# **PRE-BID Q&A**

North Eugene High School – Bid Set B – Structural Steel & Unit Masonry  
Eugene School District 4J

## **NORTH EUGENE HIGH SCHOOL** **Bid Set B – Structural Steel & Unit Masonry –** **ADDENDUM #01 - BID QUESTION/ ANSWER**

**Not Shown:**  
Stair B - S102  
Stair F - S106

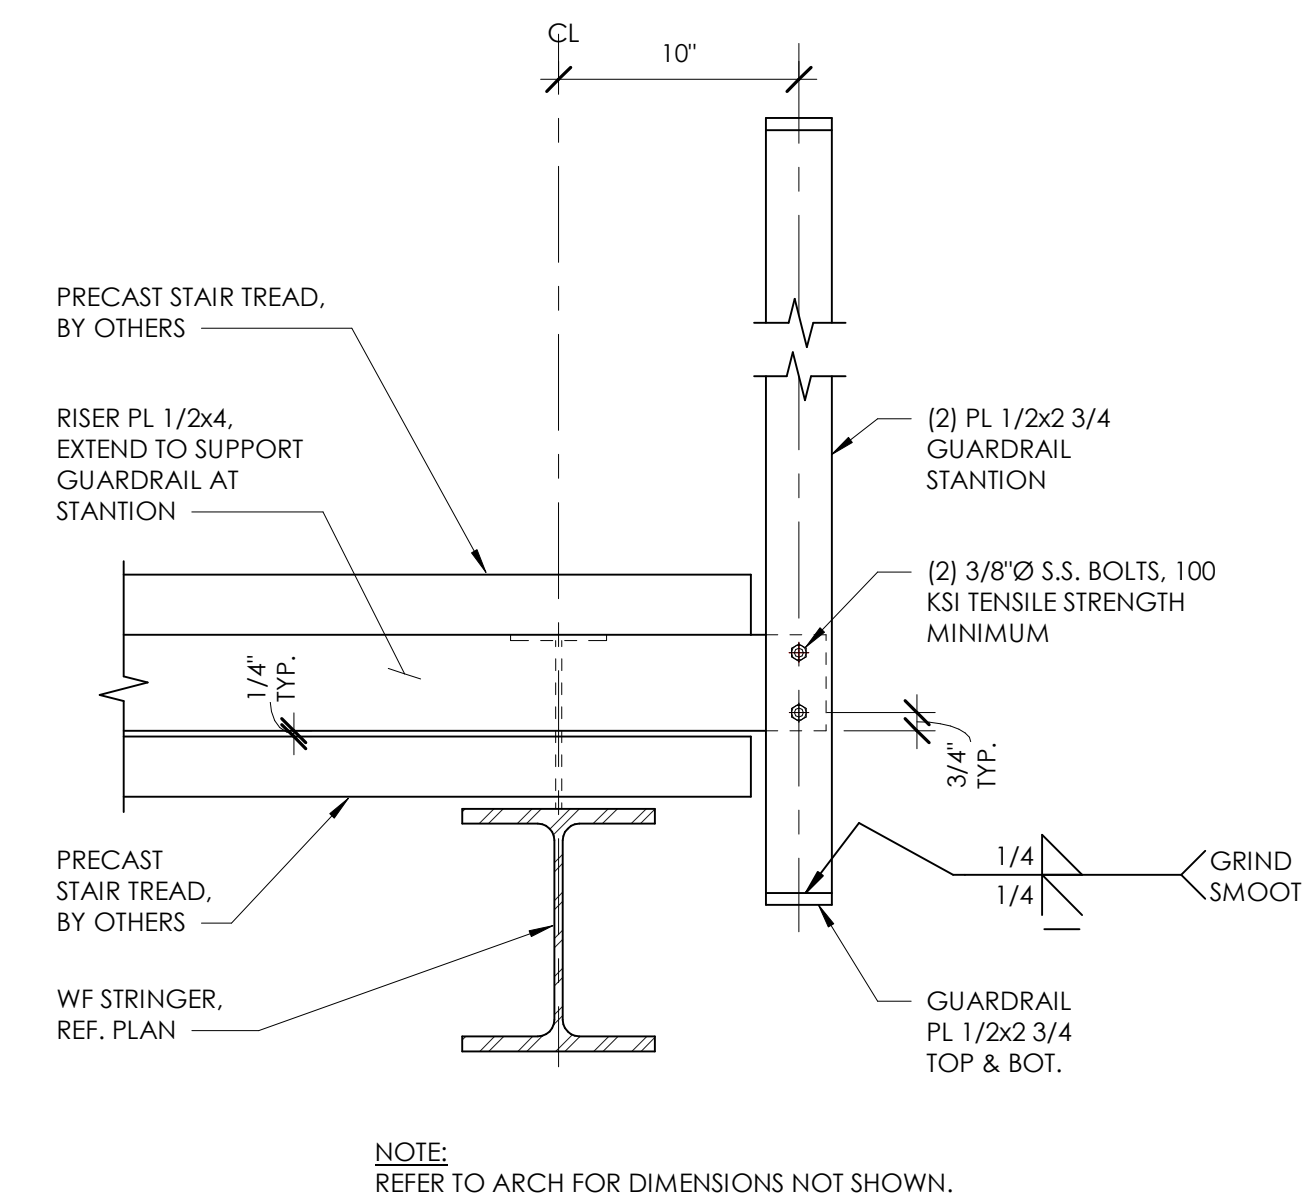
These are Fully Design-Build except for 2nd floor landings, and are shown on A-403 (Stair B) and A-406 (Stair F) for required design intent. (Rowell Brokaw)

5 GUARDRAIL STATION AT WF STRINGER  
1 1/2" = 1'-0"

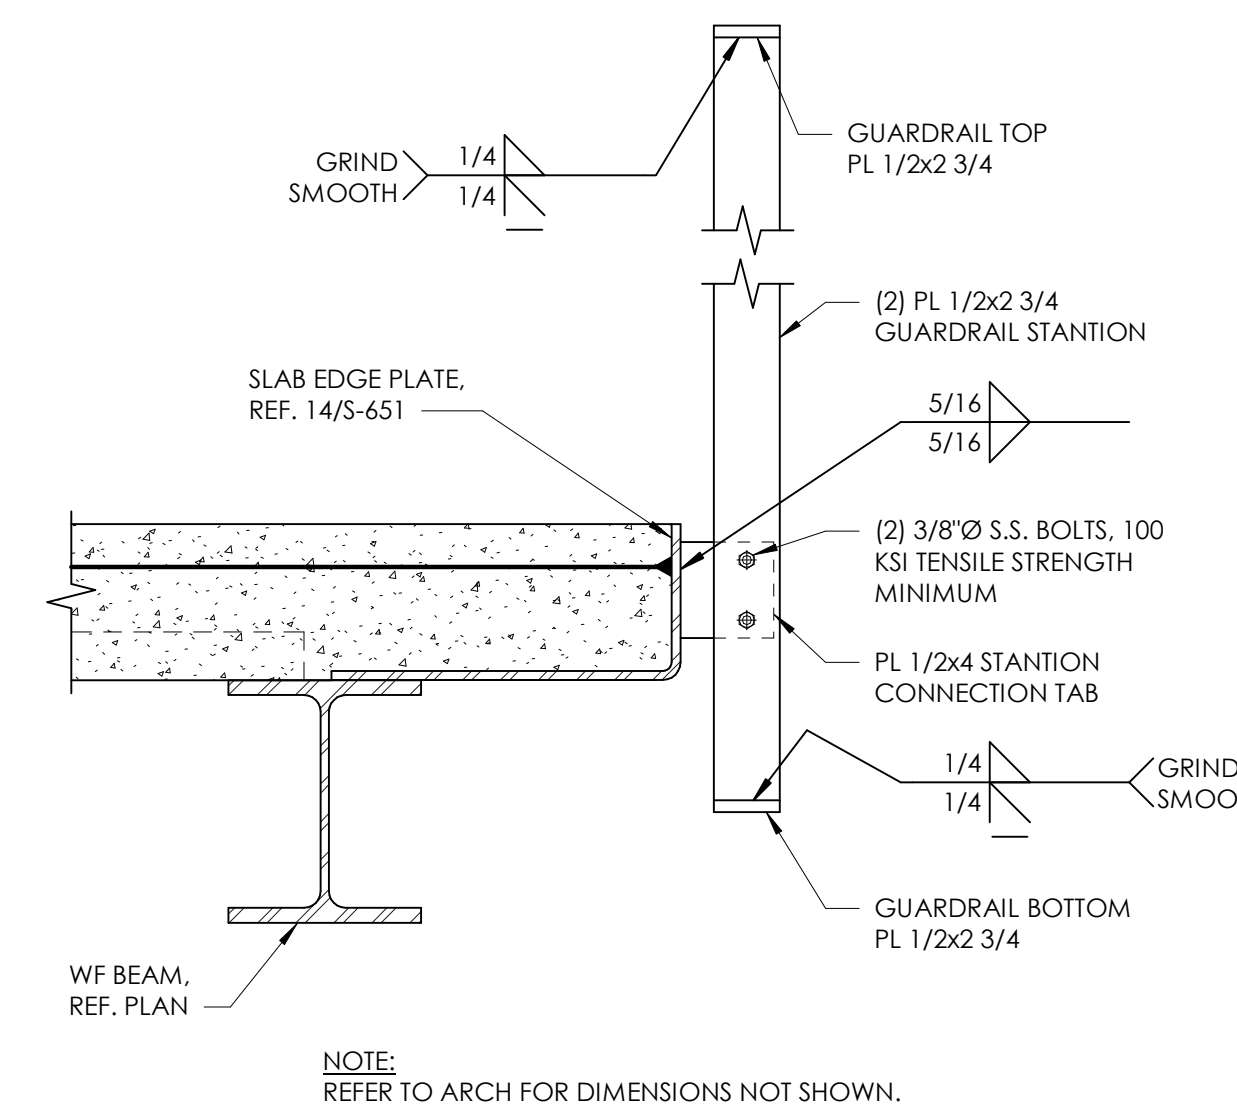
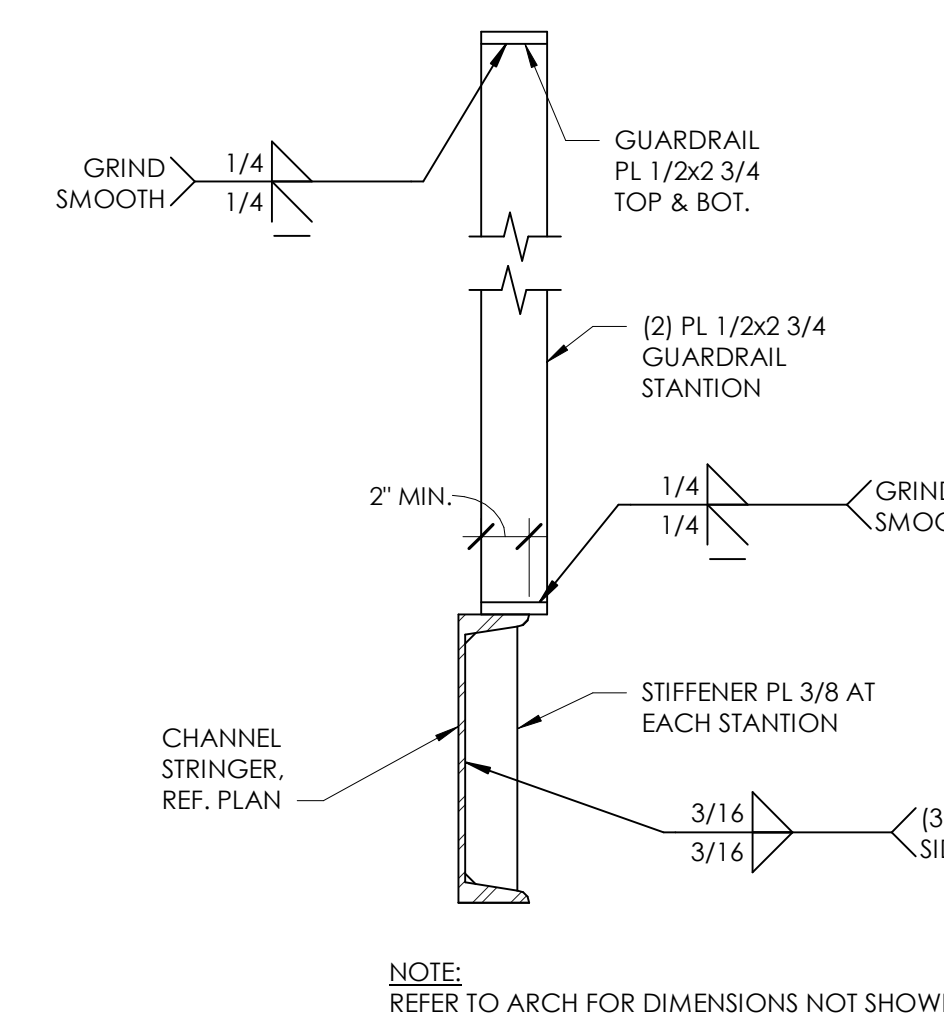
Additional details and information on all stairs are on architectural sheets A-402 through A-409. (Rowell Brokaw)

Details For  
Stair A - S101  
Stair C - S103

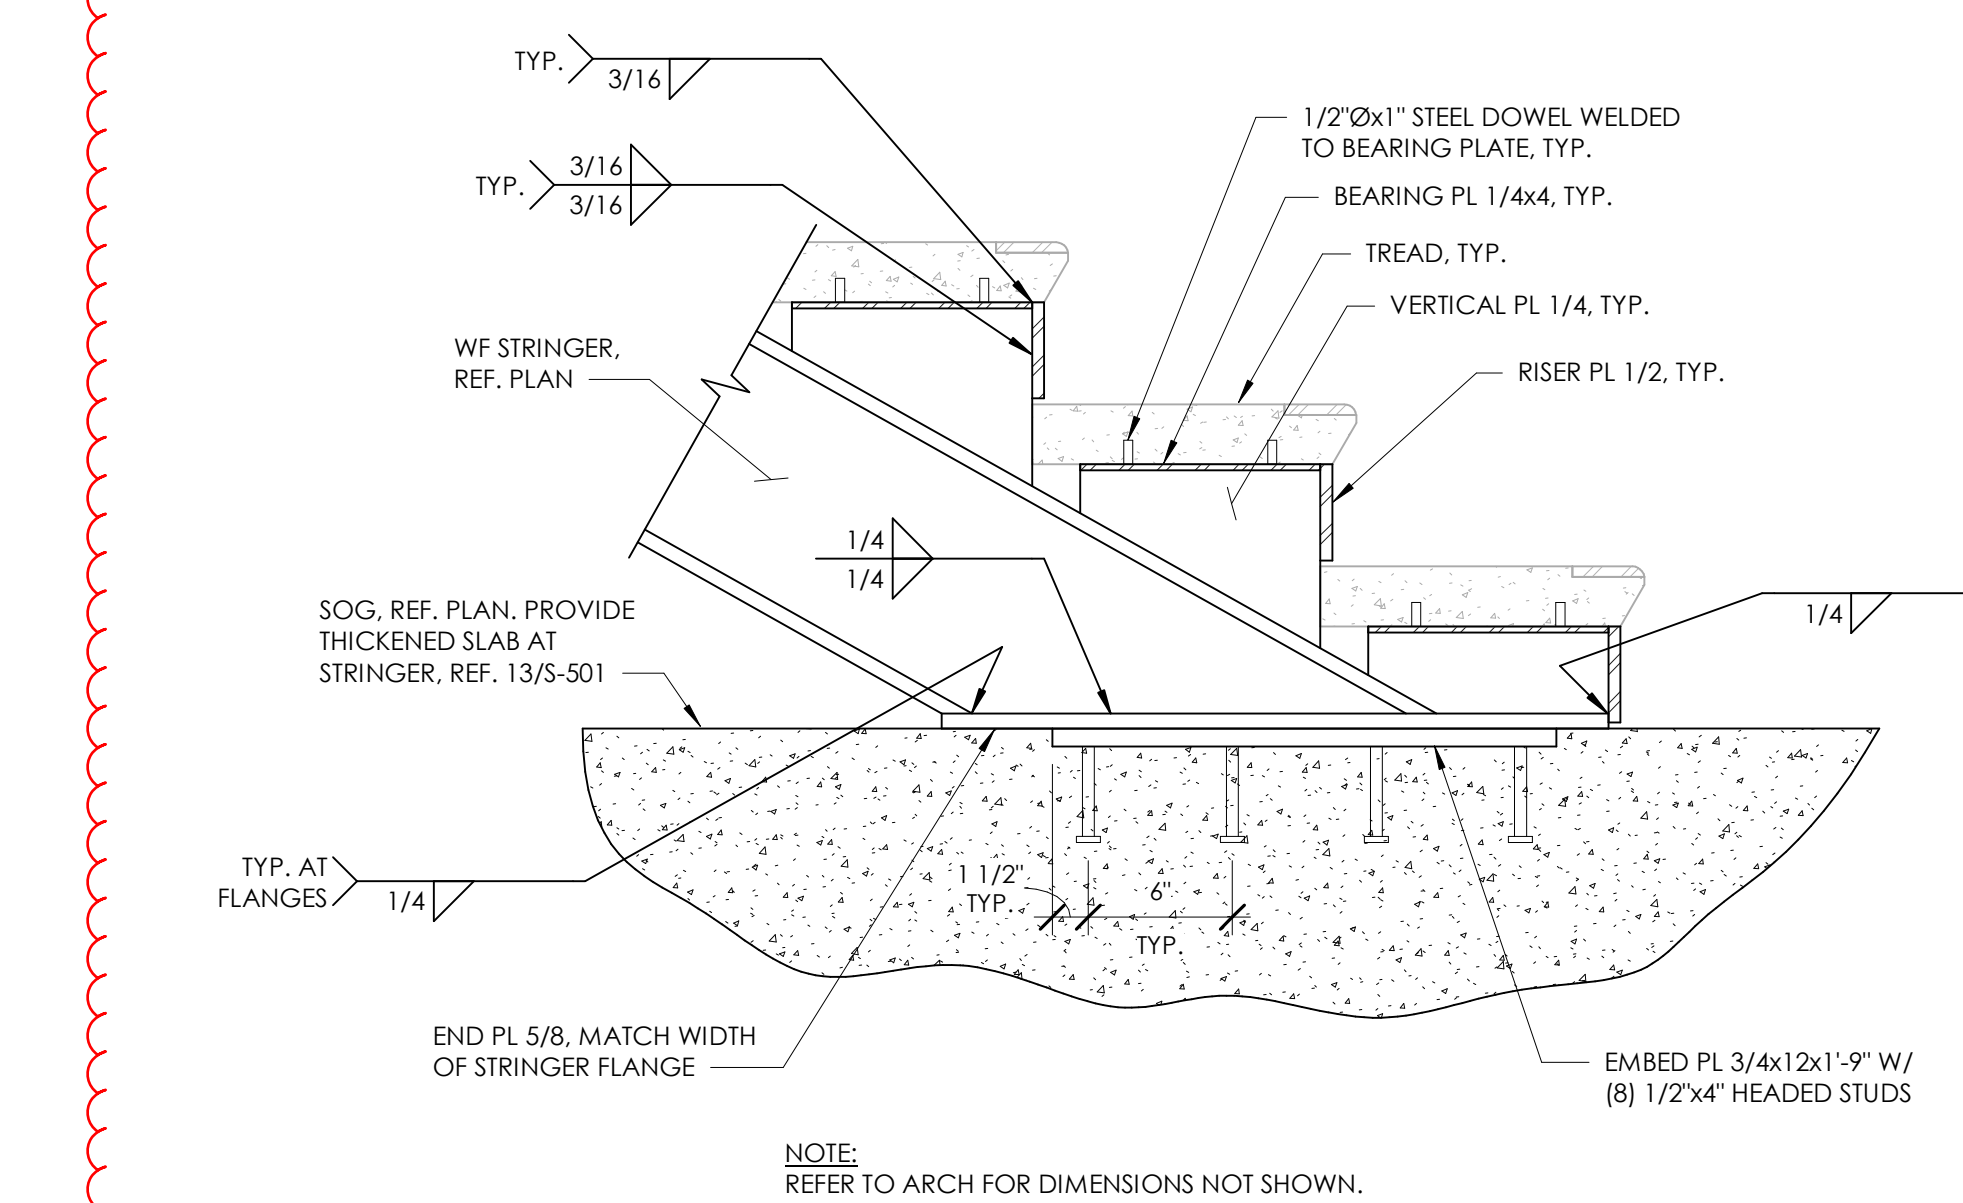
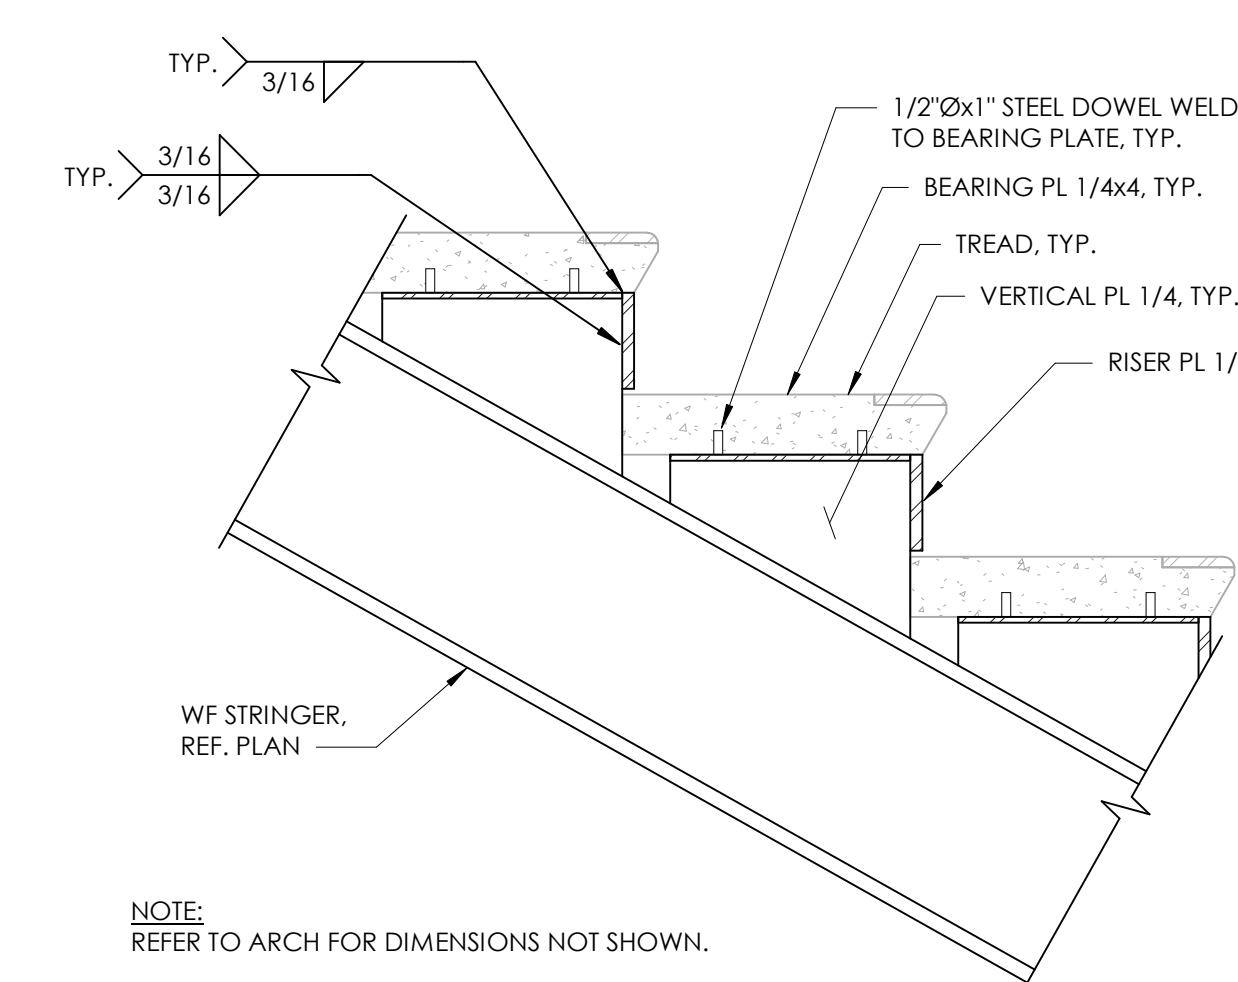
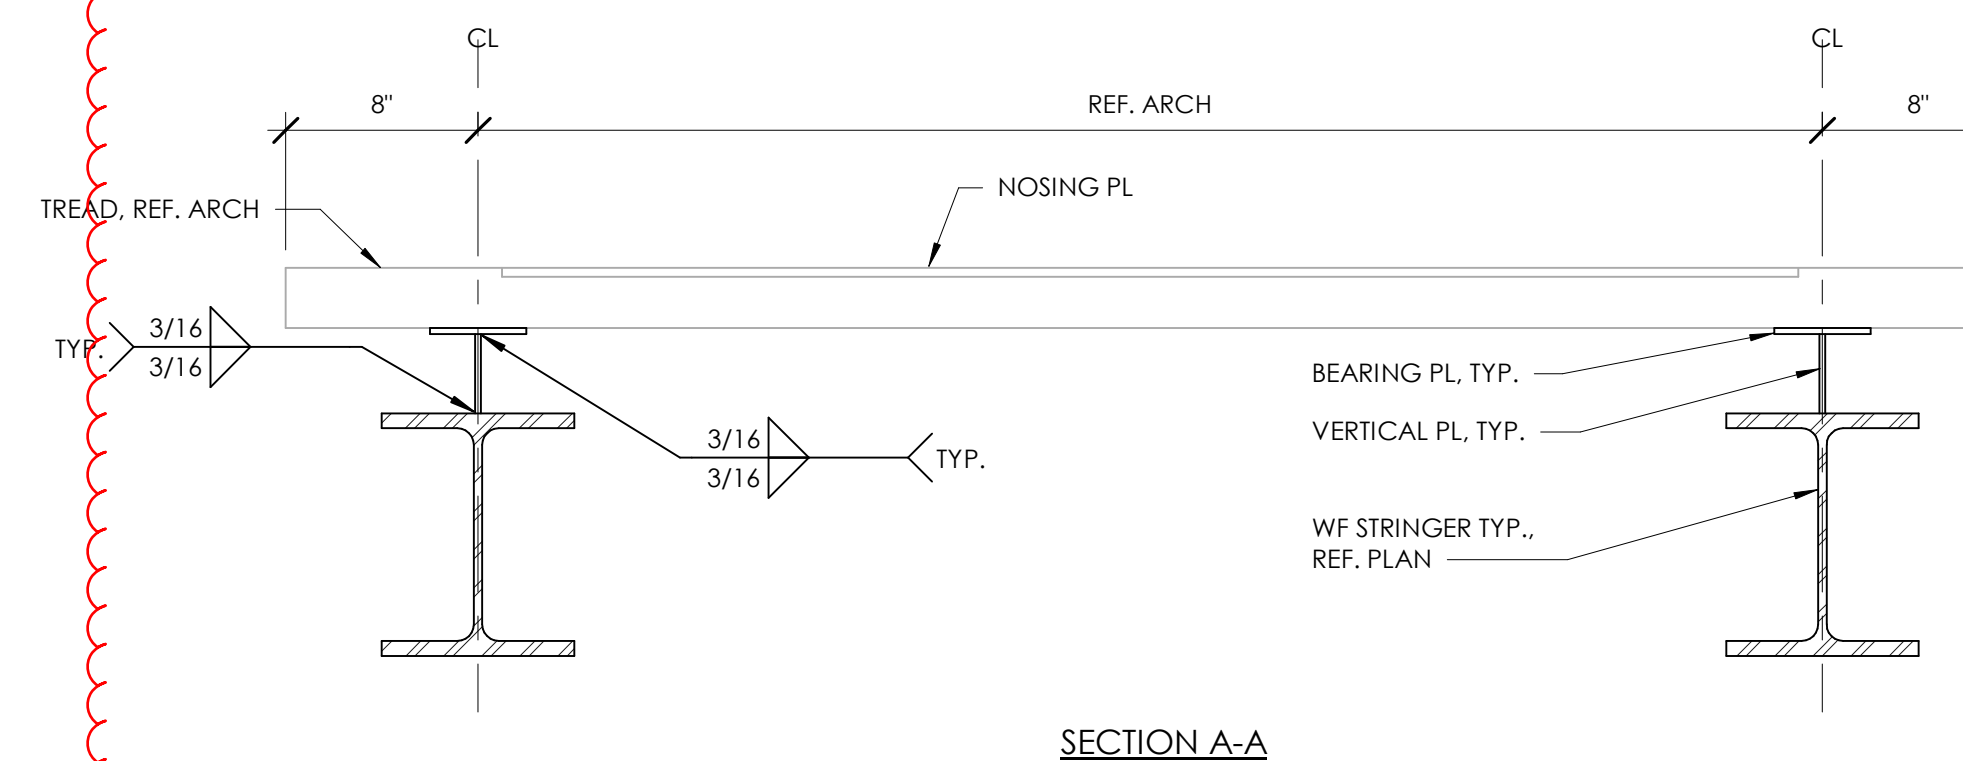
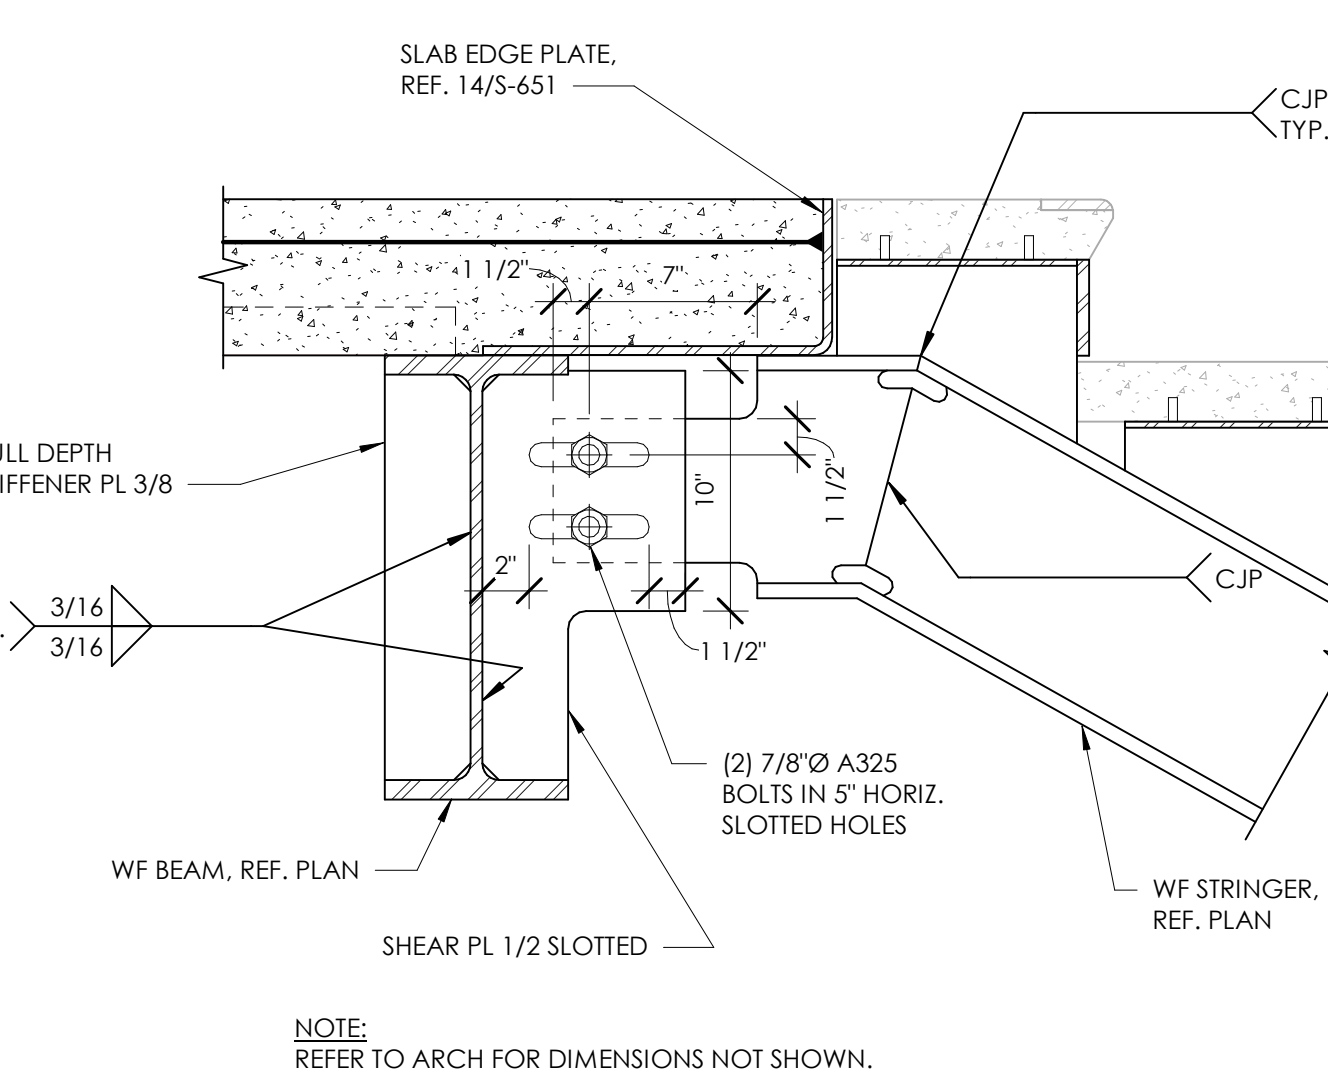
S101 and S102 precast treads, landings and attachment to stair structure are design build. (Rowell Brokaw)

Spec calls for S101 and S103 Treads and tread supports to be Design Build
